<p>Form 504</p> <p>U. S. DEPARTMENT OF COMMERCE</p> <p>COAST AND GEODETIC SURVEY</p> <p>DESCRIPTIVE REPORT</p>	
<p>Type of Survey <u>SHORELINE (Photogrammetric)</u></p>	
<p>Field No.</p>	<p>Office No. <u>T-11809</u></p>
<p>LOCALITY</p>	
<p>State <u>Mississippi</u></p>	
<p>General locality <u>Mississippi Sound</u></p>	
<p>Locality <u>Long Beach</u></p>	
<p><u>19 66 - 68</u></p>	
<p>CHIEF OF PARTY</p>	
<p><u>J. Bull, Director, Atlantic Marine Center</u></p>	
<p>LIBRARY & ARCHIVES</p>	
<p>DATE</p>

DESCRIPTIVE REPORT - DATA RECORD
T-11809

REVIEW REPORT T-11809
SHORELINE
AUGUST 1968

NOTES TO REVIEWER

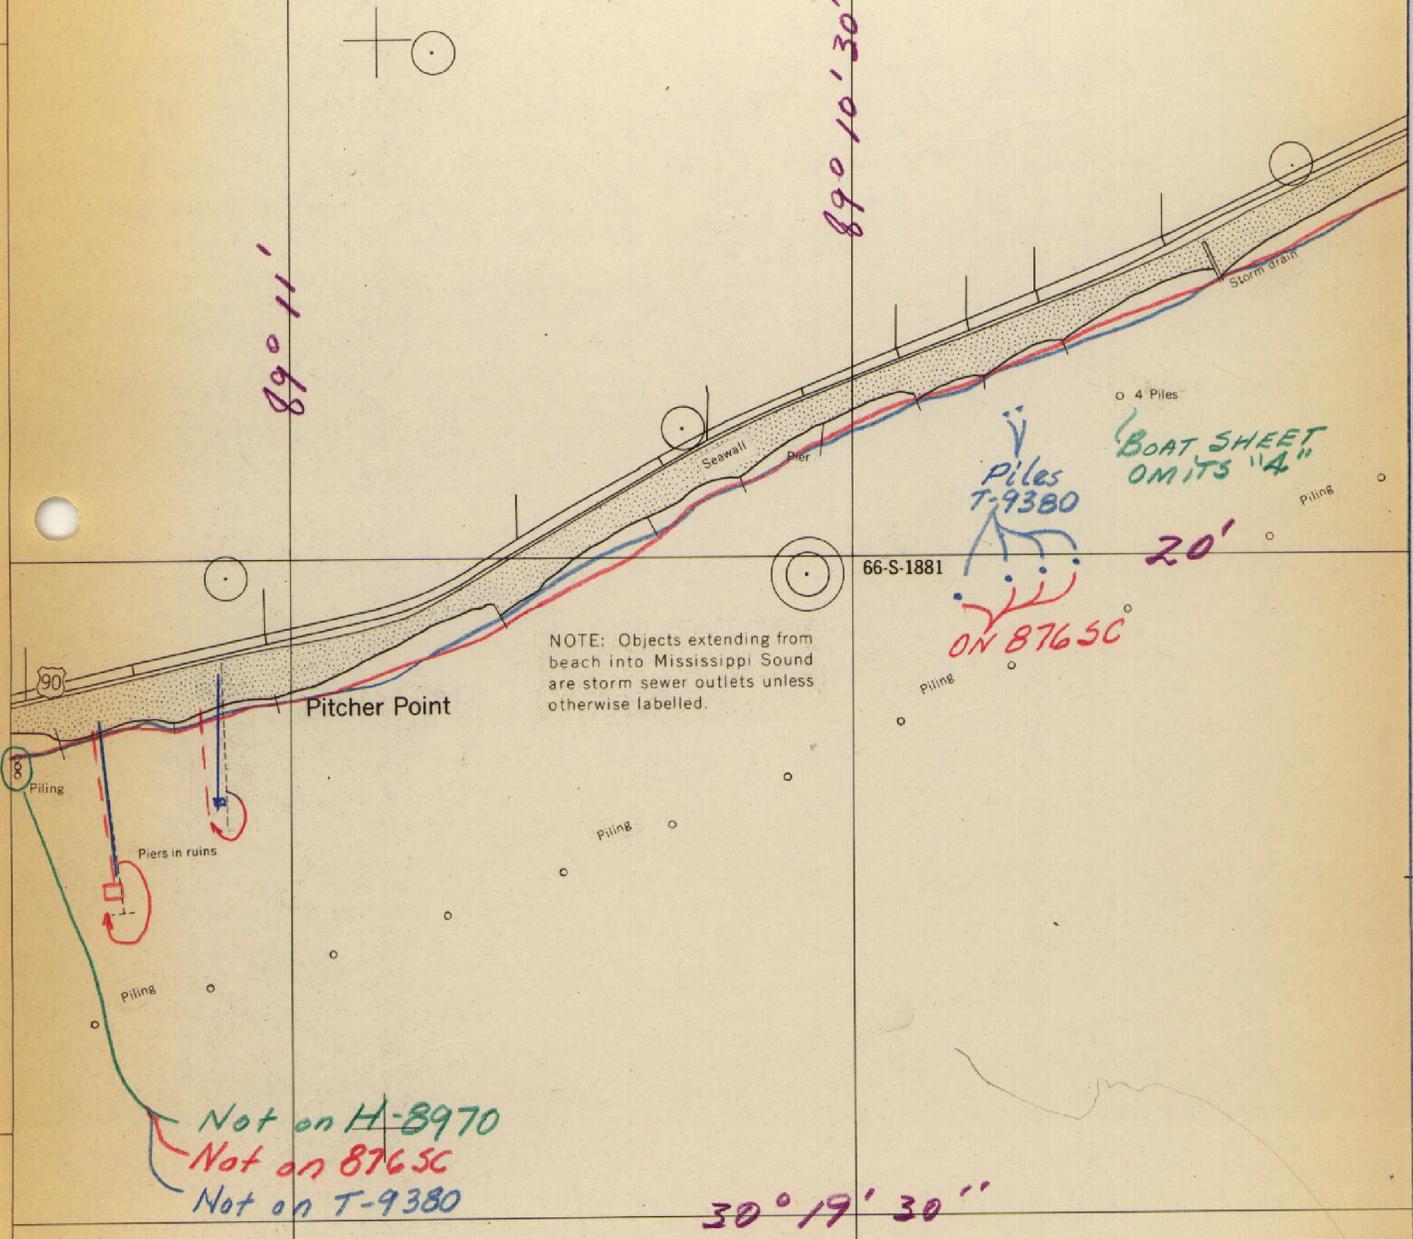
Please note Items 62, 64, and 65; particularly paragraphs (b) and (c) of Item 64.

Piles T-9380

BOAT SHEET OMITS "A"

Not on H-8970
Not on 8765C
Not on T-9380

4 Piles

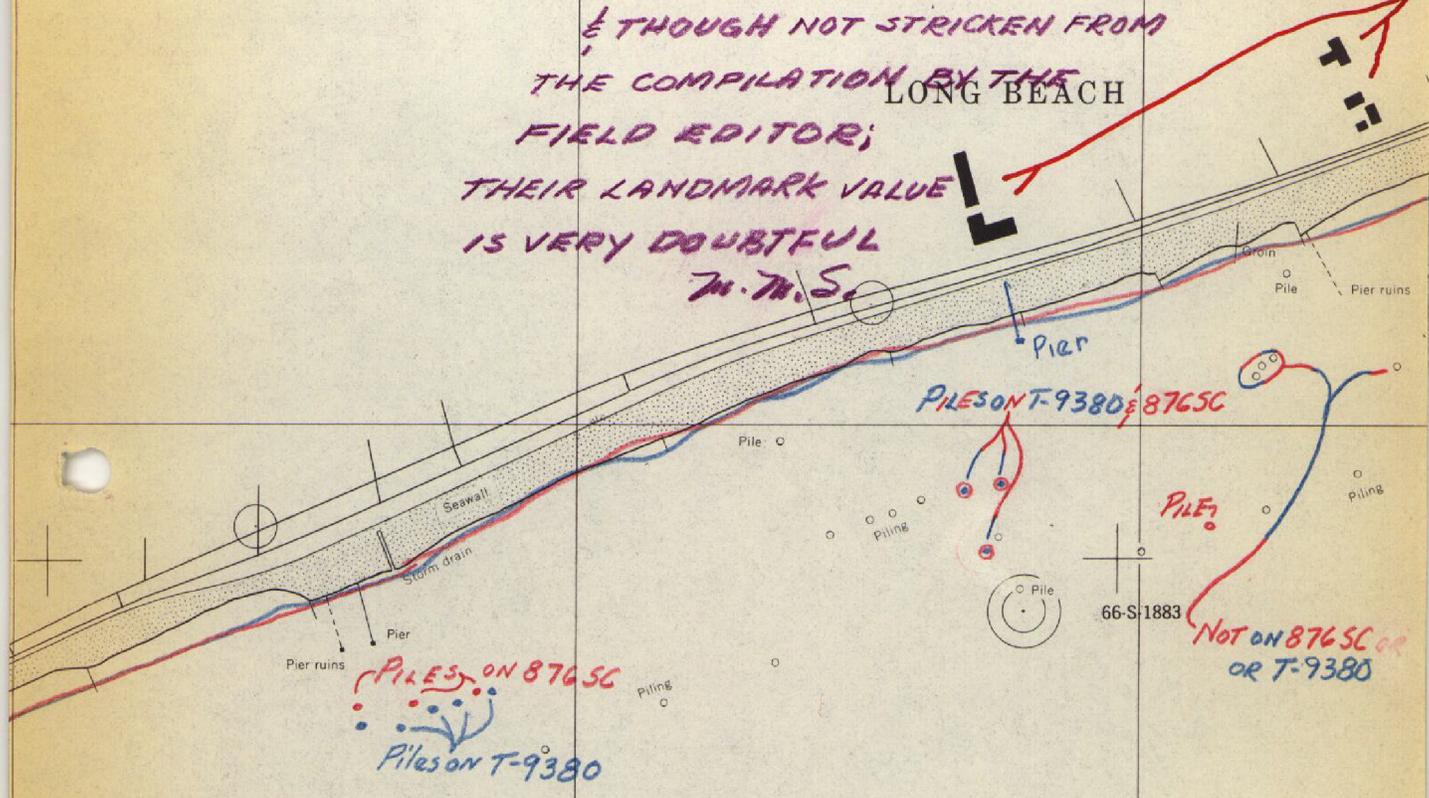
NONE OF THESE BUILDING ARE ON CHART 8765C
 & THOUGH NOT STRICKEN FROM
 THE COMPILATION BY THE
 LONG BEACH
 FIELD EDITOR;
 THEIR LANDMARK VALUE
 IS VERY DOUBTFUL
 W.W.S.

LANDMARK VALUE OF THESE BUILDINGS FOR CHARTS APPEARS TO BE QUESTIONABLE

BUILDINGS NOT ON 876 SC

SPIRE 1967 (Wood) ht = 100 (120)

NOT ON 876 SC

Not on Boat Sheets

NOT ON 876 SC OR T-9380
